**To:** Planning Committee **Date:** April 16, 2007  
**From:** Jean Lamontagne **File:** RZ 06-344033  
 Director of Development  
**Re:** **Application by Polygon Meridian Gate Homes Ltd. for Rezoning at 9200, 9240, 9280, 9300 and 9320 Odlin Road from Single-Family Housing District, Subdivision Area F (R1/F) to Comprehensive Development (CD/186)**

## Staff Report

## RZ 06-344033

BUILDING  
 ELEVATIONS  
 SHEET NO. A3.1

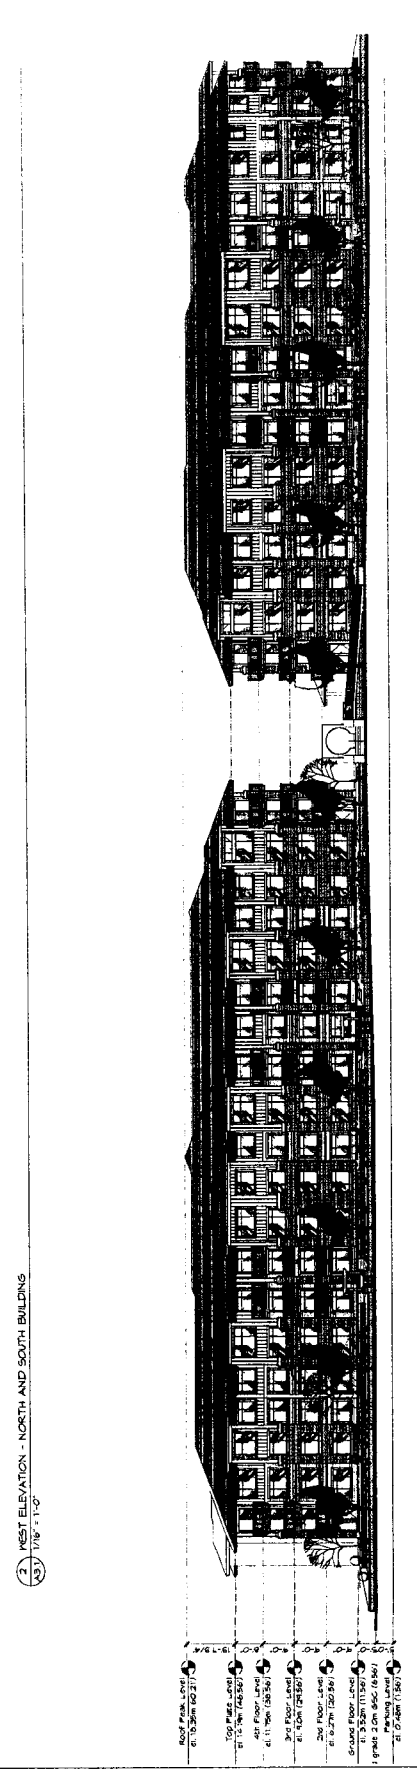
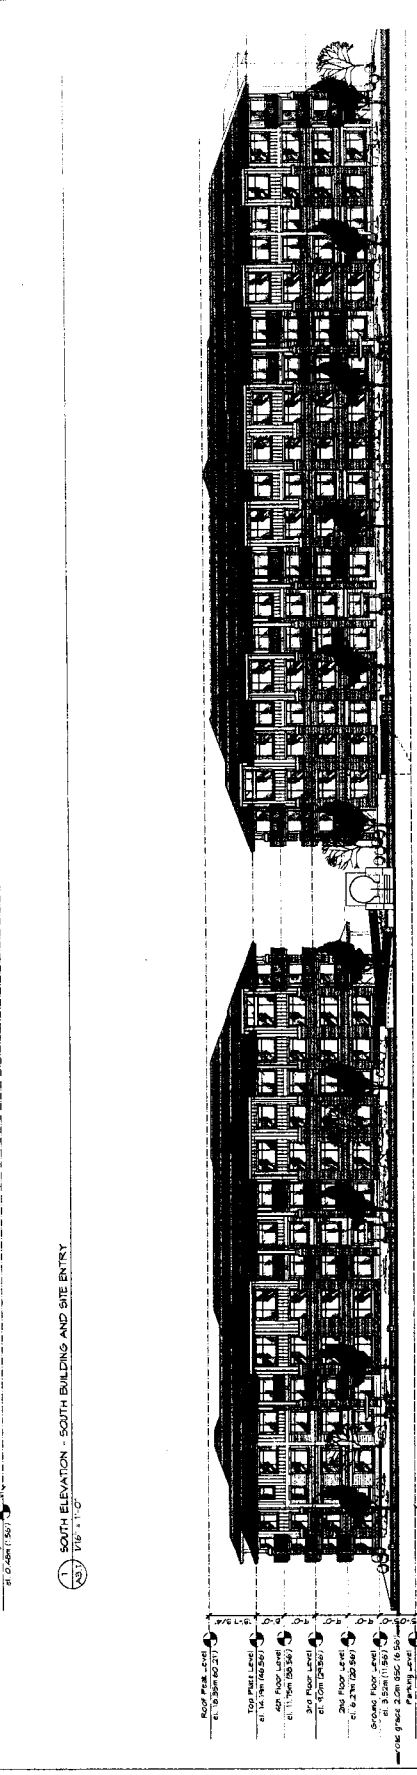
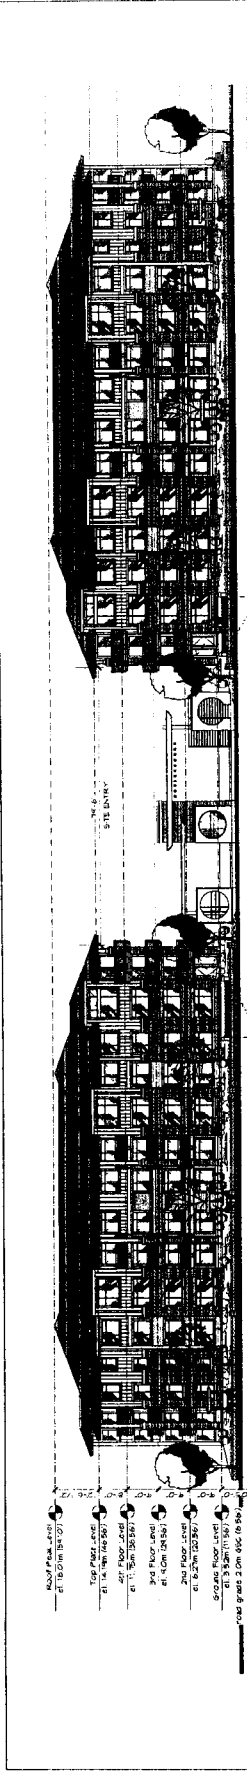
- *good unit entry features, appreciate the design changes made to address the long exterior balconies, and the minor change to the north elevation is very effective. Concerned about the roof size, consider making the eaves treatment as interesting as possible.*

*Our reduced decks have created opportunities for additional breaks in the eaves, but these are hard to achieve without making the roof excessively complicated. We are having another look to take whatever opportunities we can, but there are limits to how much change we can realistically expect. All of the roofs were smaller at the second ADP than they were at the first and we have created quite a bit of articulation with projecting bays etc.*

FIG. NO.: L1

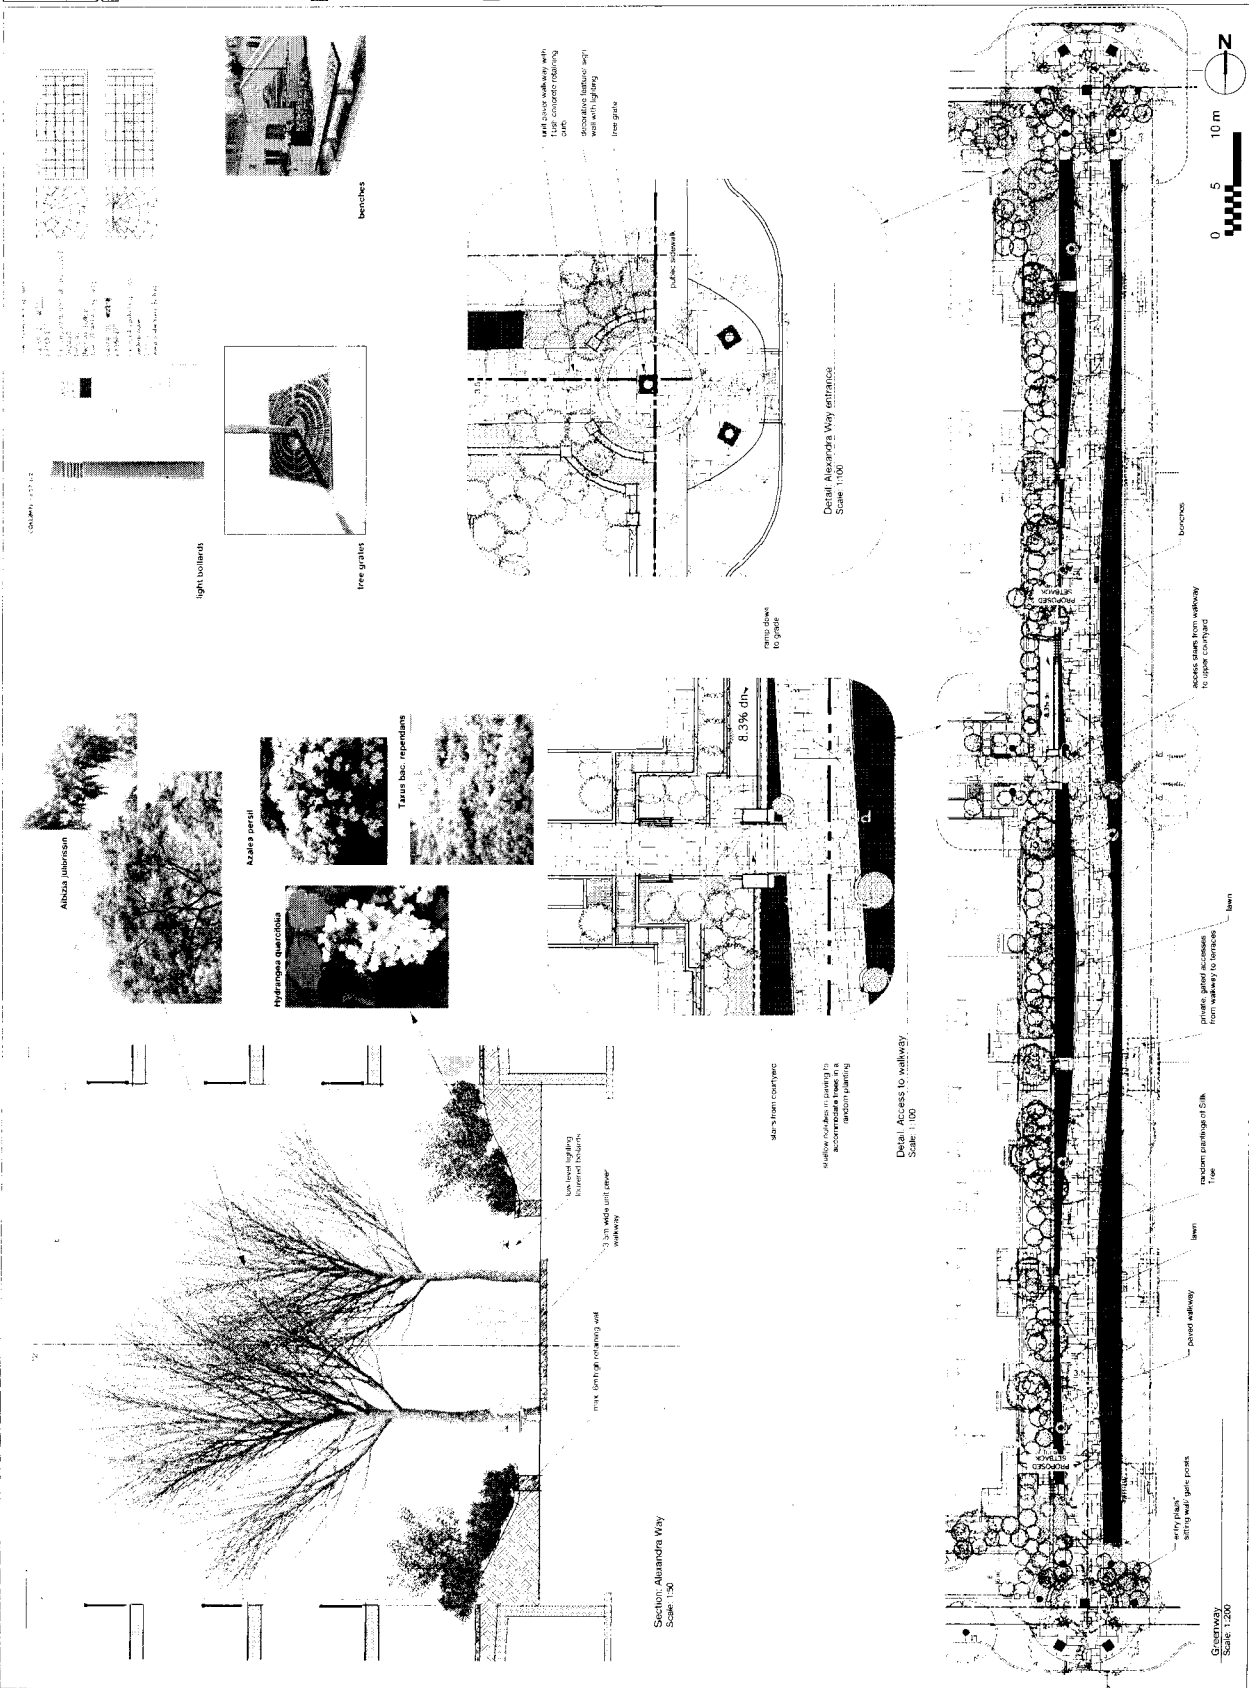
- The pathway is to be designed to accommodate pedestrians, cyclists, and other related vehicles. The proposed design includes provisions for accessibility. The change in grade between the road and the elevation of the internal courtyard is approximately 1.5 m (5 ft.). The pathway incorporates a gradual slope; at its crest at the midpoint, it is approximately 0.9 m (3 ft.) higher than at its starting points along Odlin Road and Tomicki Avenue. The slope both creates visual interest for pathway users, and diversifies the interface between the individual units fronting Alexandra Way and the pathway. In addition, it improves connectivity to the courtyard by reducing the number of risers and reducing the slope of the ramp that links the pathway and the courtyard area.

- As articulated in the area plan, Alexandra Way will be a privately owned public-access right-of-way. As a condition of rezoning, the applicant is required to register a public right-of-passage for pedestrians and vehicles (bicycle, motorized wheelchairs, scooters, etc.) that corresponds to the hard surface area to be located on the subject site. As indicated on the attached plan, the area designed to be treated as a hard surface straddles the property line and a result will be installed at the time the adjacent eastern site develops through a Servicing Agreement, thereby permitting works to be undertaken on the subject site by another party. As the hard surface will ultimate straddle property lines, the City will accept maintenance responsibility for the hard surface area. The introduction of a gravel pathway on-site at the time of development is intended to provide a temporary pathway and to ensure residents are cognisant of the pathway system. To address concerns associated with maintenance of the temporary gravel pathway, it will consist of gravel designed to establish a compacted, durable surface. Further, to reduce spill over onto the landscaped area, a pathway edge is required to be installed.

*In response to a query about the width of the pathway, Diana Nikolic advised that the width is yet to be determined, the plans show 2.5 meters; however, the City strongly prefers a minimum width of 3 metres.*

*Widening the pathway from 2.5m to 3m will reduce planting, but is acceptable. Additional landscaping would need to be installed at a later date by the neighbouring developer when the temporary path is taken out. Anything greater than 3m in width becomes too wide and will take up almost all of the greenway (negating the green aspect).*
